August 30, 1996

Subject: Quad Cities Station Units 1 and 2, Response to NRC Review of Individual
Plant Examination Submittal - Internal Events
NRC Docket Nos. 50-254 and 50-265

Response to NRC Staff Evaluation Report and Modified Quad Cities IPE

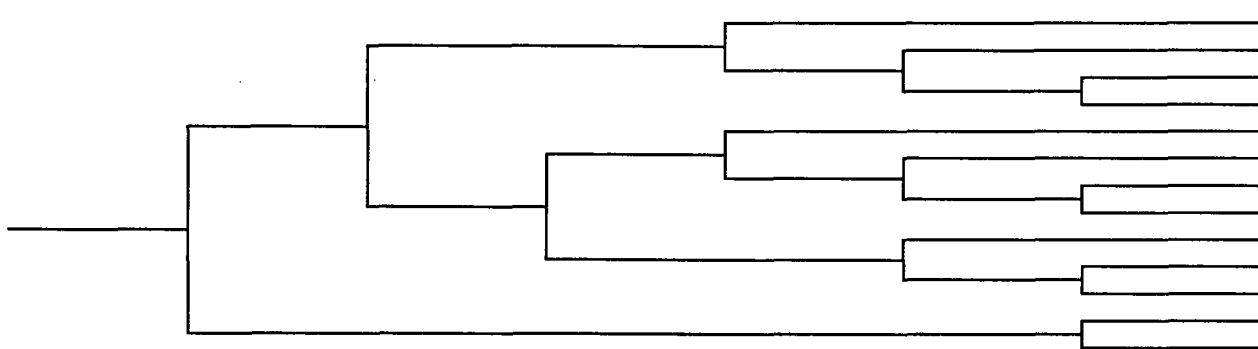
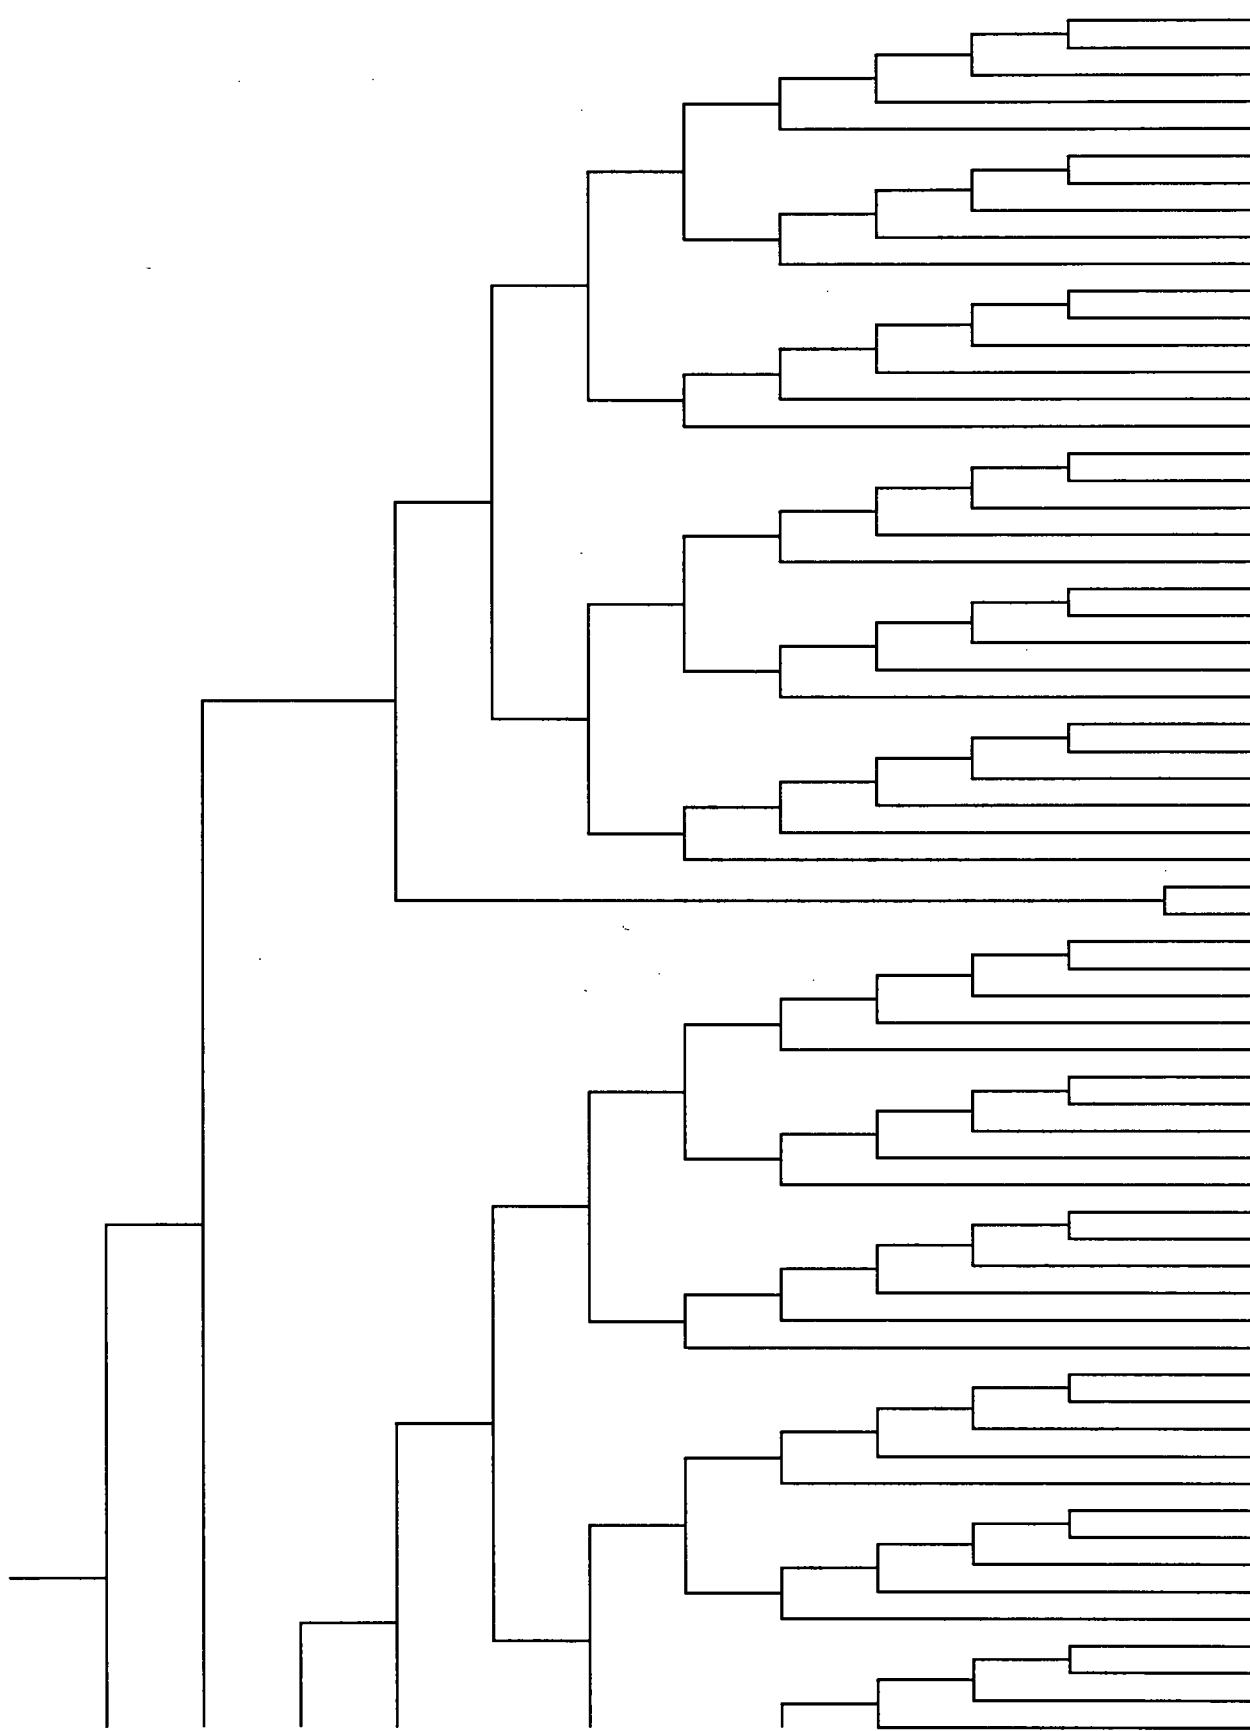
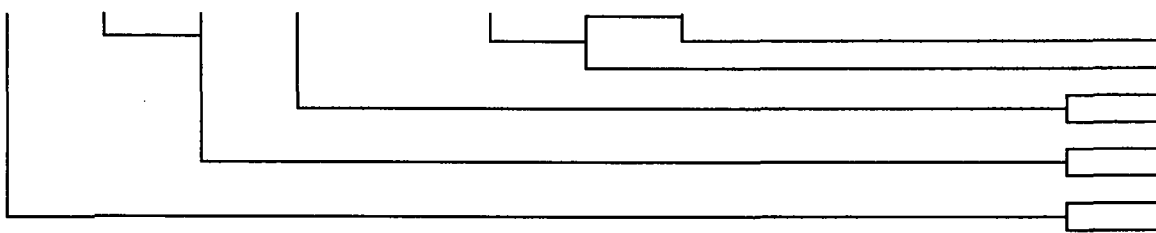
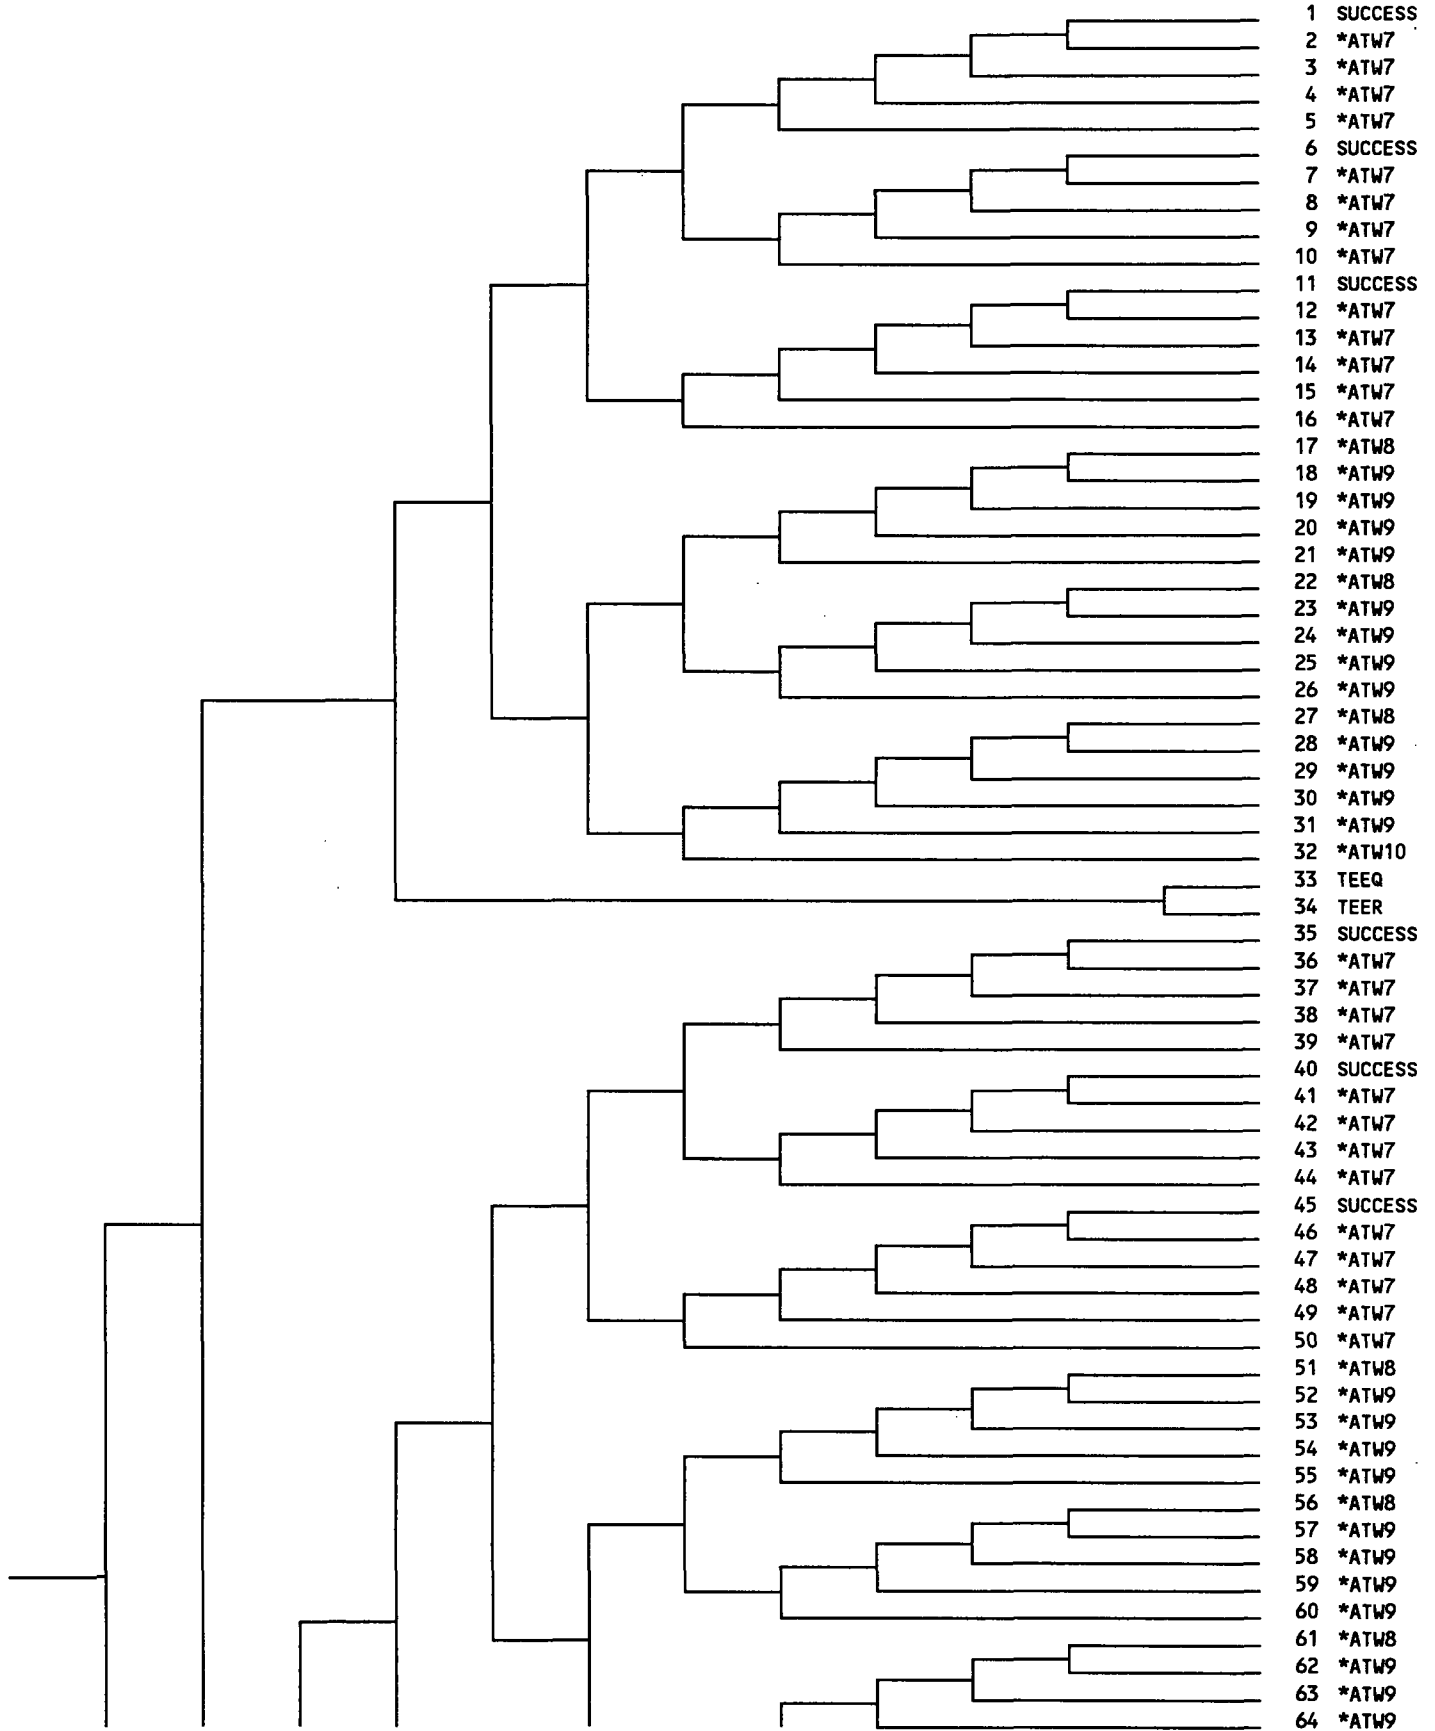
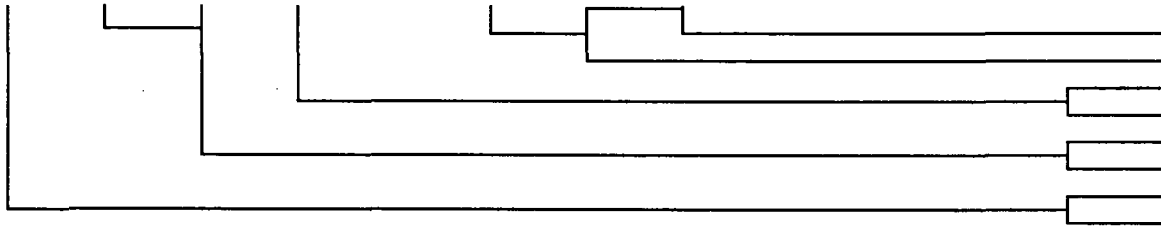
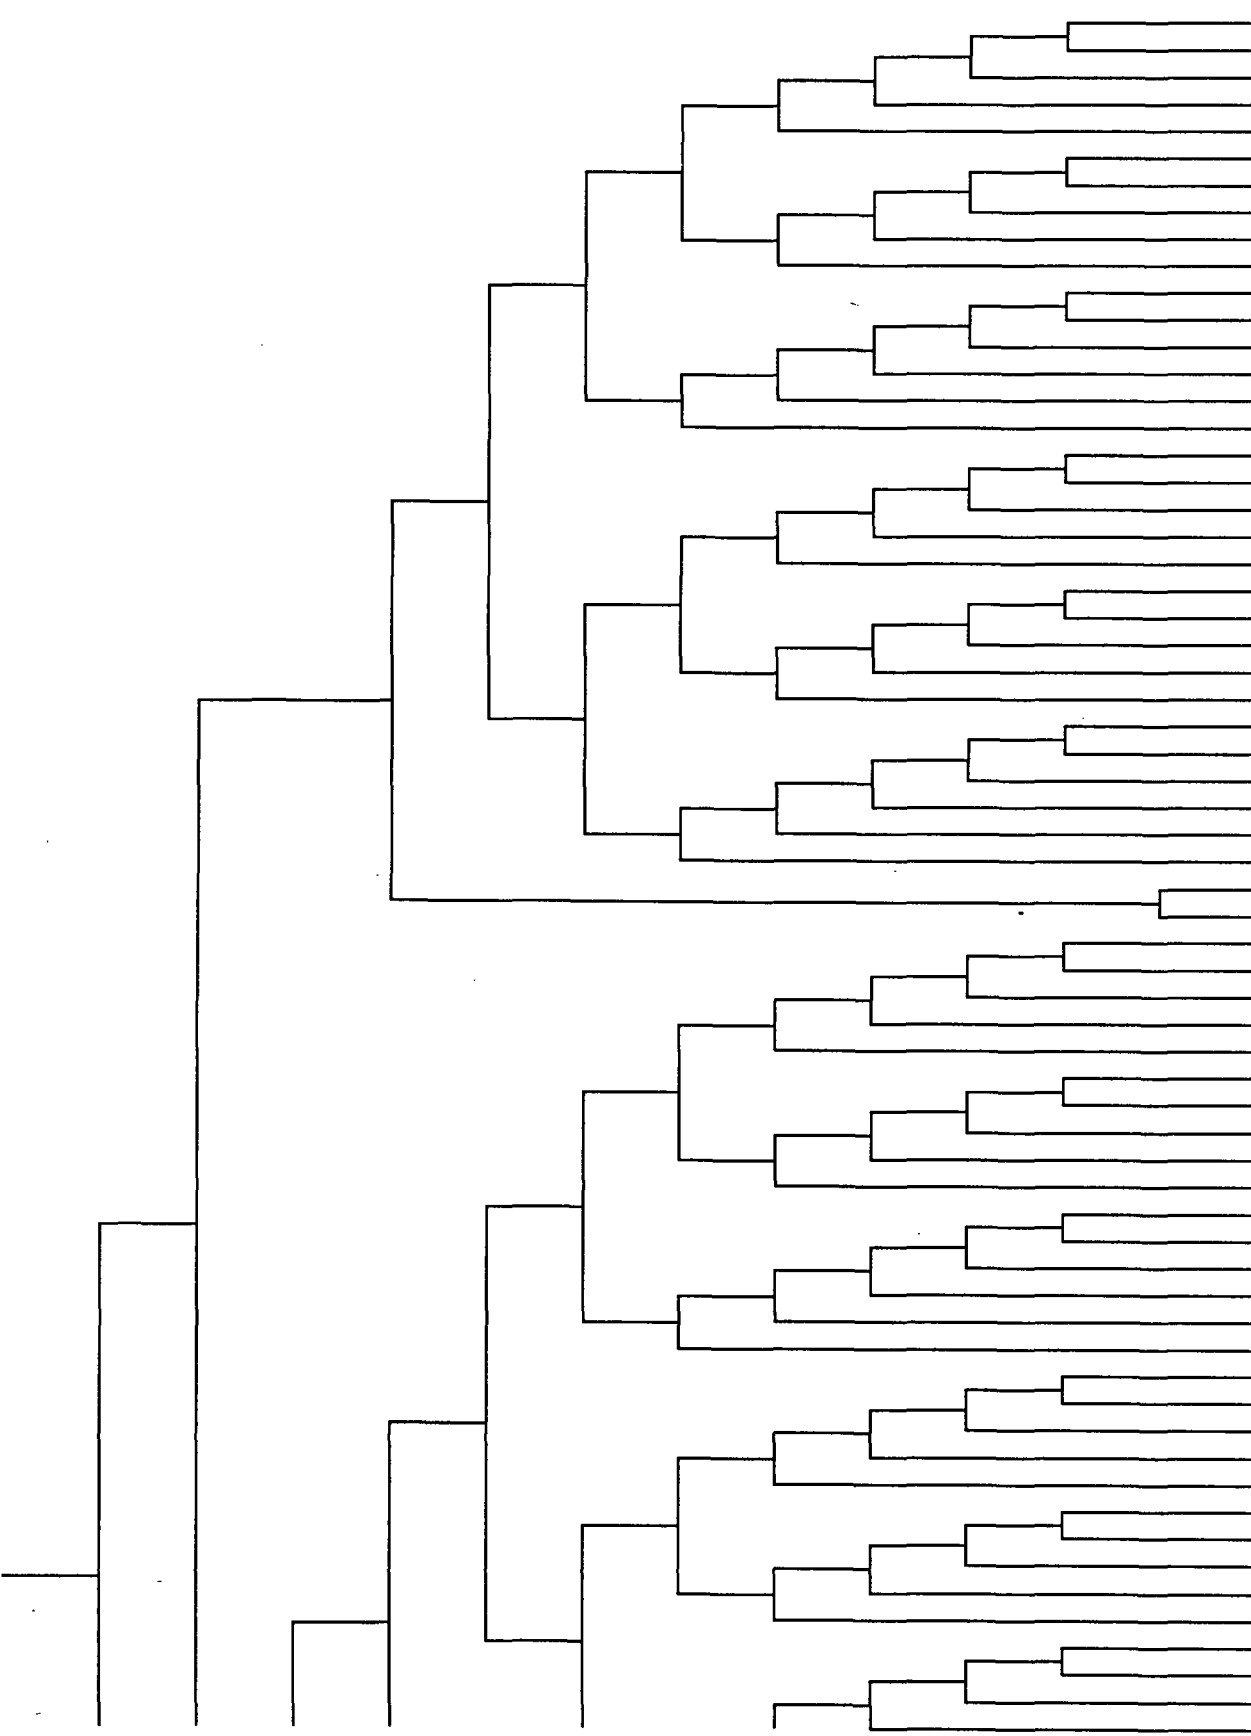
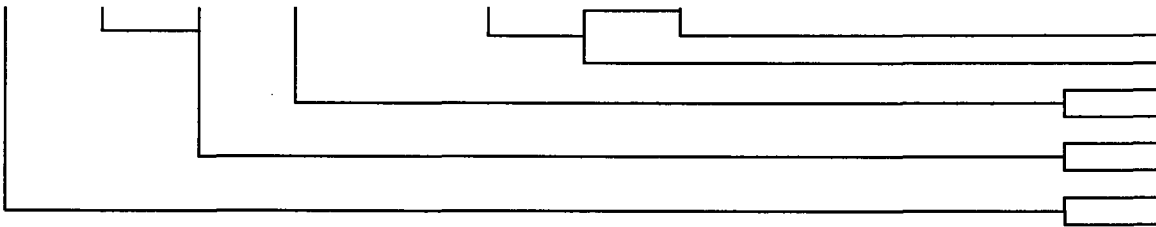
2. Modifying the common cause failure (CCF) factors;
3. Revising the success criteria for ATWS to include the Operator Action to inhibit ADS in the ATWS Event Tree;

The operator action to inhibit ADS was explicitly modeled in the original IPE for the Small and Medium LOCA events. The assumption in the original IPE that operator action would be 100% successful in inhibiting automatic depressurization for the other events was reviewed in response to the concern in the SER. The assumption was found to be conservative for all other initiating events except ATWS. Therefore, the ATWS PRT was revised for the Modified

As discussed later in the writeup for Modification 6, the main impact of including operator action to inhibit ADS for ATWS was to increase the CDF contribution of the ATWS initiator.
